Report to the Future Melbourne (Planning) Committee

**Ministerial Planning Referral: TPM-2018-14
CW2 and CW3 – Victoria Harbour 945-981 Collins Street, Docklands**

5 March 2019

PLANNING REPORT

SOUTH FACING FACADE - PROPOSED ADJUSTMENTS - OPTION 3

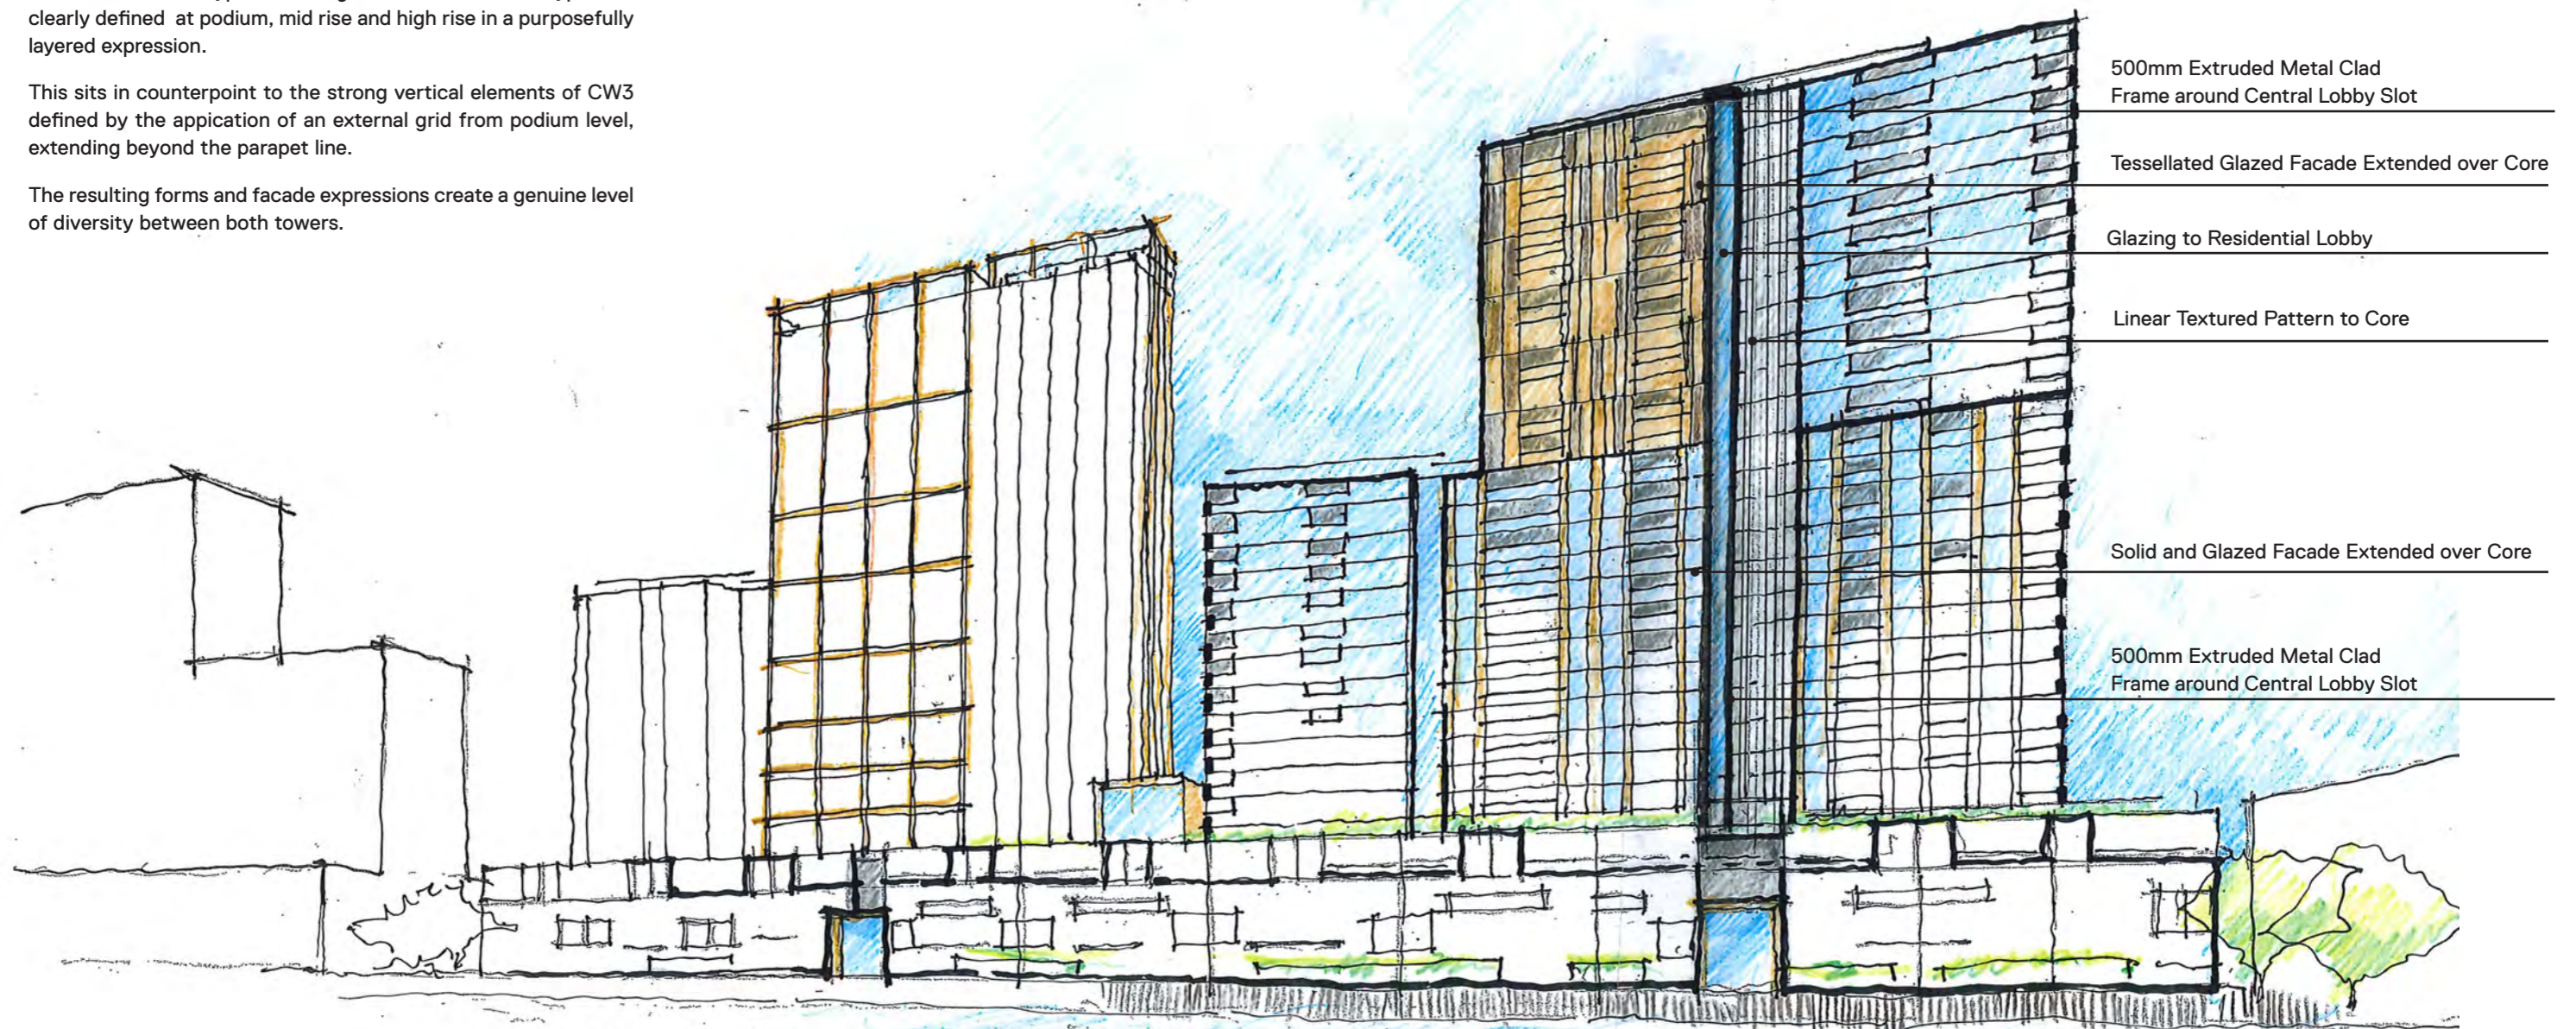
2. We support the changes depicted in 'option 3' which introduces a 500mm deep metallic frame around the glazing to the lift lobby as well as the extension of the glazing façade over the core. We believe that these changes would provide greater façade depth and emphasise verticality.

CW2 south facade has been rationalised to reduce the prominence of the lift core by overglazing on the eastern side of the residential lobby. The articulation of the various facade typologies is further expressed by the introduction of a 500mm deep expressed frame around the residential lobby glazing.

Figure 6.4.6 - Conceptual variation in height through the built form along Collins Wharf.

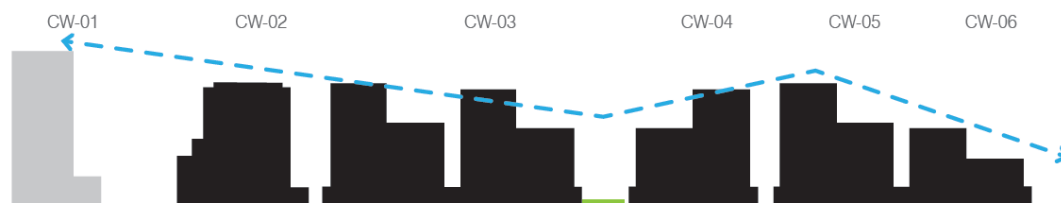
This is the first planning application on Collins Wharf since the endorsement of the Development Plan in August 2017 and a variation to the Development Plan is already being sought. There are a number of sites in this precinct which are identified in the Development Plan for development in the near future. There is a concern that if this variation is to be supported, further departures from the Development Plan will be sought in the future.

It is recommended therefore that the GFA and heights sought be consistent with Development Plan. A reduction in both height and GFA can be addressed as required via conditions of permit.

Proposed ground floor showing the private and communal gangways to Yarra Walk

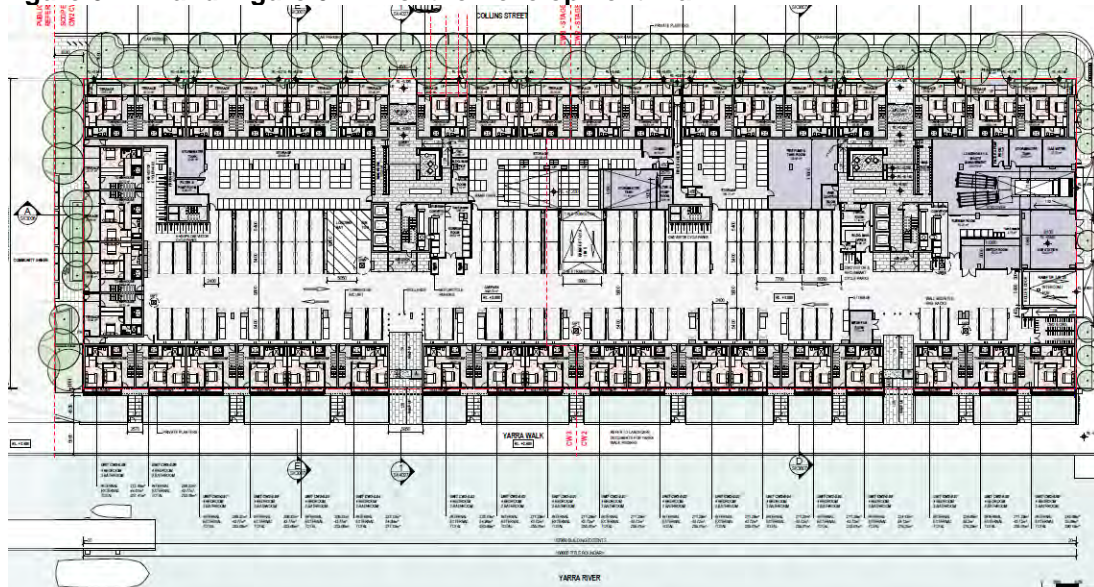
The provision of two pedestrian access points to the site from the wharf is supported from an urban design and safety perspective. The access ways provide a unique sense of address for residents of the building, will activate the southern elevation and increase the sense of personal safety for users of the wharf by providing an escape to and from Yarra Walk.

Proposed Ground Floor

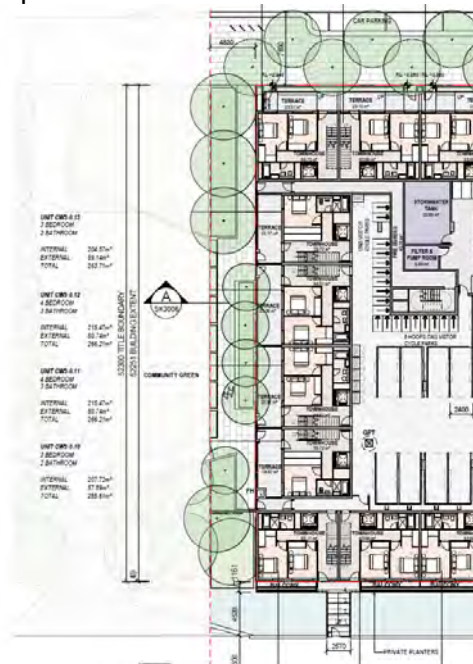
Both the Open Space Planning Team and the City Design Studio are not supportive of the private entries and building services abutting the Community Park.

It is understood from the Development Plan that this will become a Public Open Space that will be managed by the City of Melbourne. The application proposes that the eastern edge of the space will be paved to serve as pedestrian access to the CW3 private town houses. Provision of a separate access to private property is not supported because it increases the paved / circulation space in an already small park (1,440 m²) for the benefit of a small number of residents. Two emergency access ways and a fire booster are also proposed to abut to the Community Park. It is recommended that no access or building services rely on using the Community
